FINAL ENVIRONMENTAL IMPACT STATEMENT

WESTCHESTER JOINT WATER WORKS RYE LAKE WATER FILTRATION PLANT Purchase Street, Harrison, New York

September 28, 2022

Figure 3A-1 Details of proposed ornamental fence and gate

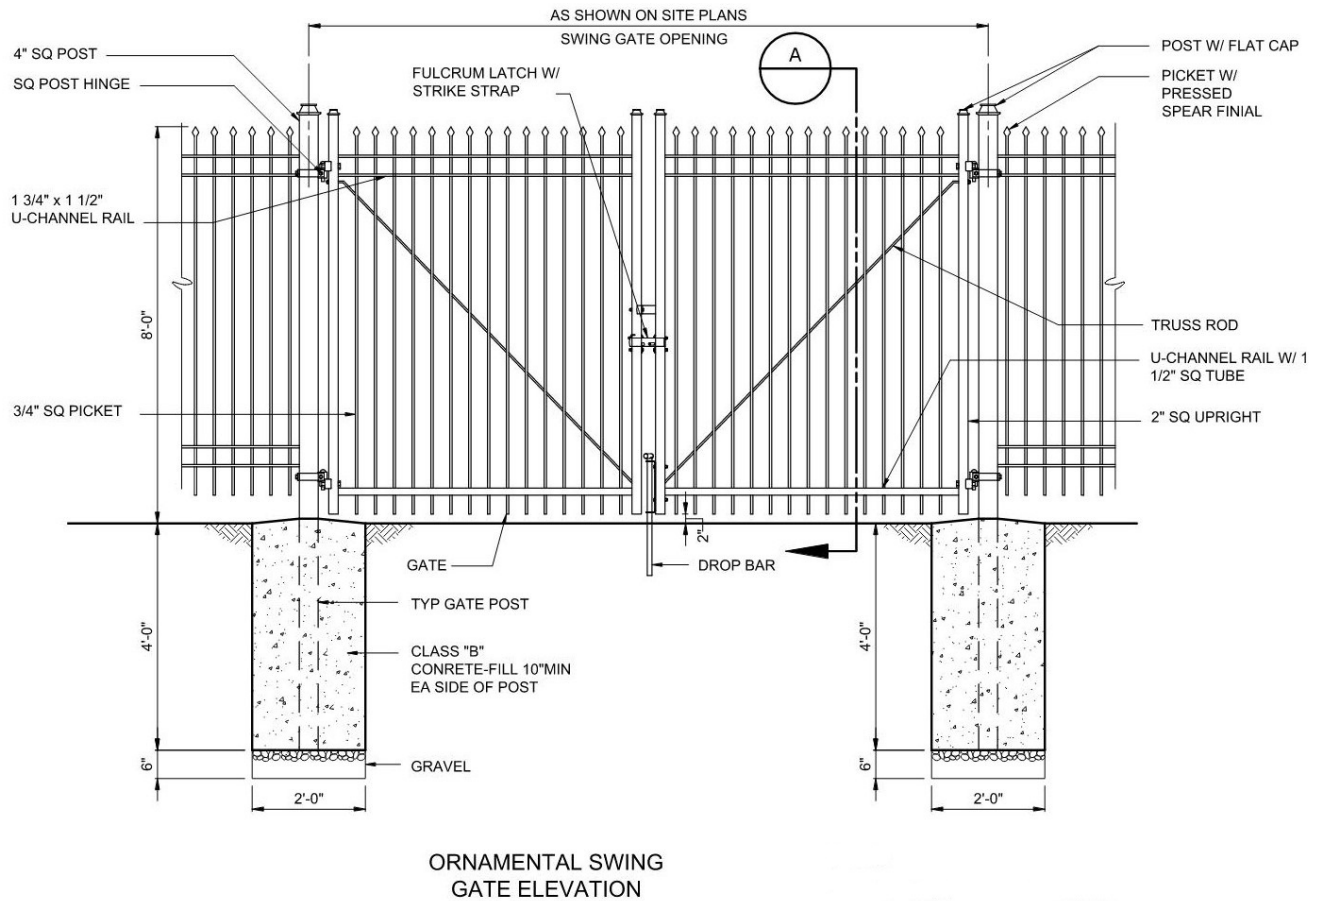
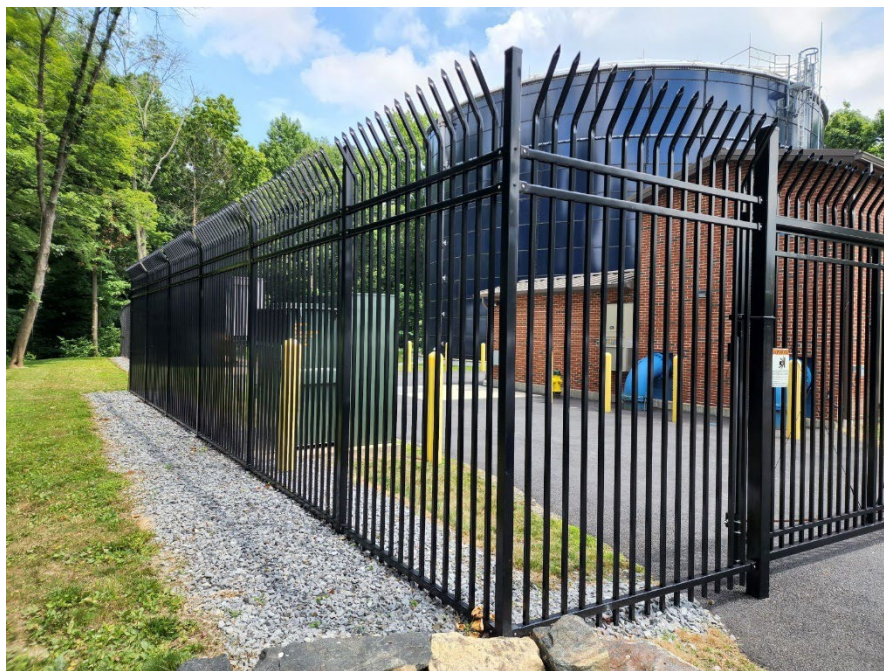
The DEIS [page 1-4, paragraph C] states that a 6' high retaining wall will be located on the southern side of the plant. Additionally, a 10' high fence will surround the filtration plant. Please set forth the purpose of the 6' high retaining wall and why it is not redundant to the 10' high fence.

Please state the nature of the 10' high fence and whether it is a chain-link fence or not. Please provide alternatives to having an industrial-style chain-link fence. Please consider making efforts to have this fence conform to the Town of Harrison zoning laws which require fences no higher than 4'/6' rather than applying for a variance from the Town of Harrison Planning Board and any other town, county and state boards to increase the height of the 4'/6' chain-link fence to 10'. Please explain to us, as your prospective new neighbors, why we should have to stare at several hundred feet of 10' high chain-link fence built 80' from our playground, meeting house and graveyard next door. Please explain why our neighbor Joe Billone's house will be 75 feet from this 10' tall chain-link fence. Please explain why our caretaker's apartment at the corner of our meeting house will be 100' from this 10' tall chain-link fence.

Presently, the Proposed site is bordered on two sides by old stone walls. We believe that similarly constructed stone walls would blend in more with the existing stone walls and better integrate the filtration plant site with the character of the surrounding neighborhood. Please explain why constructing a new similarly sized stone walls could not serve the same purpose as a 10' high chain-link fence.

The six (6)-foot high retaining wall will be located on the southern side of the plant by the emergency generators and is necessary as a result of the regrading of the southern portion of the site to level the area for the loop road and the electrical equipment. The fence is required by the New York State Department of Health (NYSDOH) for security purposes. NYSDOH recommends an eight (8)-foot chain link fence with three (3) feet of barbed wire for security fencing for all filtration plants. The Project proposes to install an eight (8)-foot spiked anti-climb ornamental fence along the northern and western portions of the facility in lieu of the barb wire. A request has been submitted to NYSDOH to install this ornamental fence as a substitute for the recommended eight (8)-foot

chain link fence with three (3) feet of barbed wire. **Figures 3A-1 and 3A-2** provide information on the proposed fence details and an example of it already installed at another WJWW facility.
